Project No. 2628-066
R.L. Harris Hydroelectric Project
Comments on Draft Environmental Impact Statement (DEIS)

ATTACHMENT A

COMMENTS ON FERC STAFF'S RECOMMENDED ALTERNATIVE

Figure 1 Incremental Increase in Wetted Perimeter Associated with 300 cfs and 450 cfs Continuous Minimum Flow Compared to Green Plan (January to April)

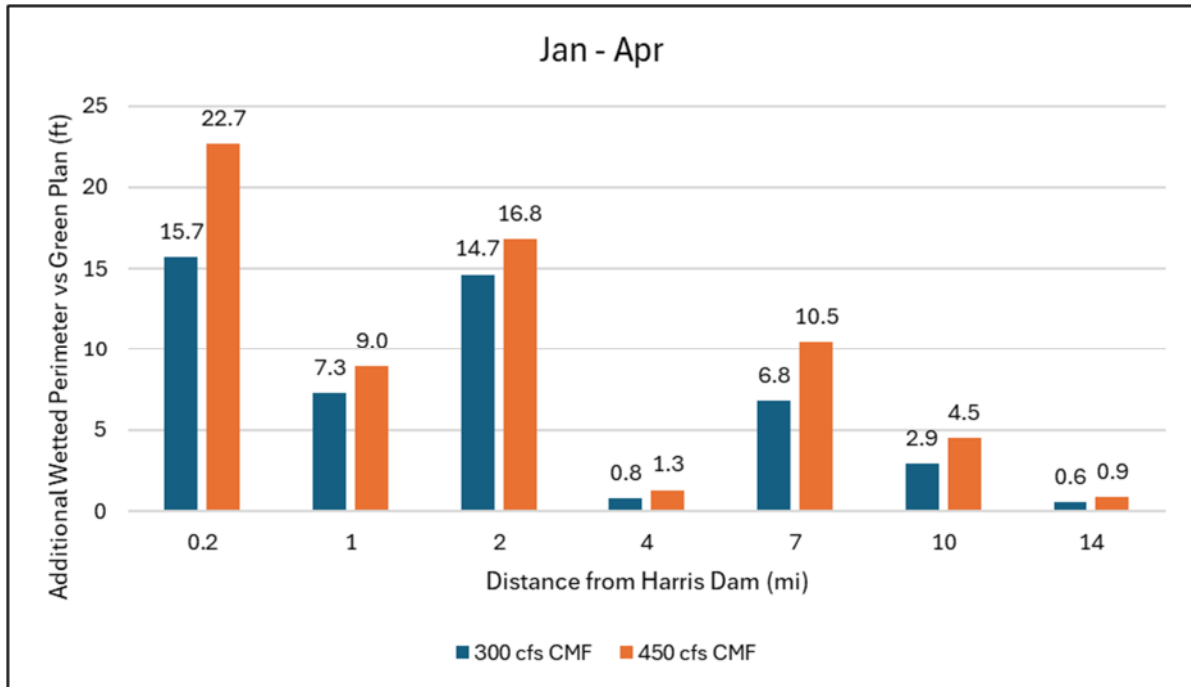
When compared to current (Green Plan) operations, modeled increases in wetted perimeter for the 300 cfs scenario ranged from 0.5 feet to 24.9 feet, and incremental percent increases in wetted perimeter ranged from 0.2% to 7.1% (Table 4). The incremental increases in wetted perimeter under FERC's seasonal flow regime, when compared to the 300 cfs scenario, ranged from 0.1 feet to 7 feet, and incremental percent increases in wetted perimeter ranged from 0.1% to 2.0%. The incremental wetted perimeter increases (feet) associated with the 300 cfs year-round and FERC's DEIS-recommended continuous minimum flow scenarios compared to the Green Plan are depicted in Figure 1 (January to April), Figure 2 (May to June), and Figure 3 (December).

ARTICLE 402: LAKE HARRIS WATER LEVEL MANAGEMENT

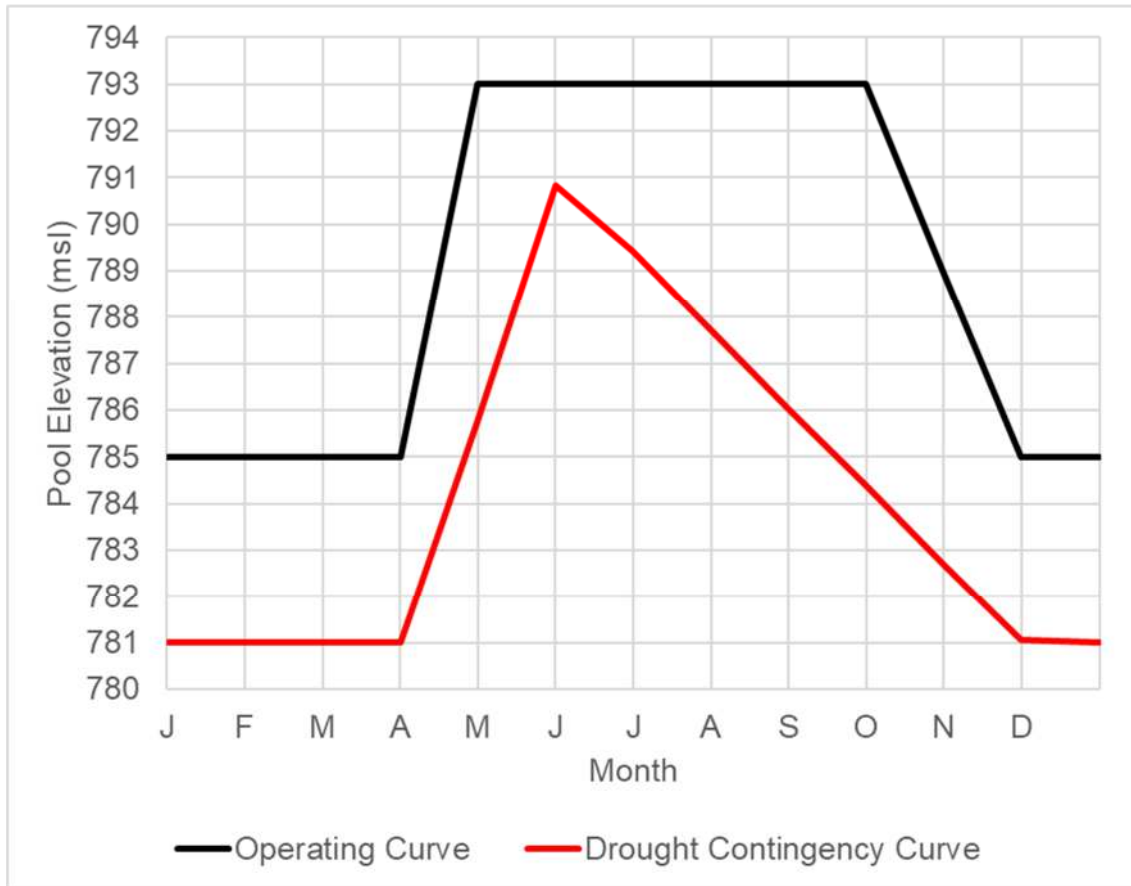
- Alabama Power notes the use of the November 2022 Memorandum of Understanding between Alabama Power Company and the U.S. Army Corps of Engineers in the wording of this revised license article is consistent with how FERC described Alabama Power's responsibilities under Article 13(c) of the existing Harris license.

- This proposed license article has been modeled after project operation and lake level requirements for Alabama Power's other storage reservoirs (e.g., the Weiss, Neely Henry, Logan Martin developments of the Coosa River Project and the Martin Dam Project). As described in the DEIS, "From May 1 through September 30, Harris Lake pool level is maintained *at or near* elevation 793 feet, *depending on inflow conditions* [emphasis added]." (DEIS, pg. xiii). Alabama Power tries to maintain the reservoir at or near the operating curve; however, the operating curve represents the maximum elevation of the reservoir before flood control operations are required. As described in Exhibit B, "Harris Reservoir is maintained at or below the elevations specified by the Harris operating curve except when storing floodwater."

- During normal operations, the lake level will typically be slightly below the operating curve; these levels should not be considered a deviation. While Alabama Power realizes that deviations may be defined under the Project Operation and Flow Monitoring Plan, the proposed edits to this license article makes clear normal operations will not be considered either a planned or unplanned deviation.

- During periods of low inflow, the lake level will be below the operating curve but these levels are neither a planned nor unplanned deviation. Alabama Power strives to keep the lake levels as high as possible during periods of low inflow; but because these are natural occurrences, they should not be considered deviations.

Upon issuance of the license, the licensee shall operate the Harris Project in accordance with the operating curve and elevations as shown in the figure below and described herein unless operating for flood control and navigation consistent with the November 2022 Memorandum of Understanding between Alabama Power Company and the U.S. Army Corps of Engineers (Corps).

Operating Curve: The operating curve reflects the maximum elevation at which the reservoir may be maintained before implementing the Corps’ flood control measures. Flood control measures, as identified in Article 403, Flood Control Operations at the Harris Project, are to be implemented when the reservoir level is at or above the operating curve.
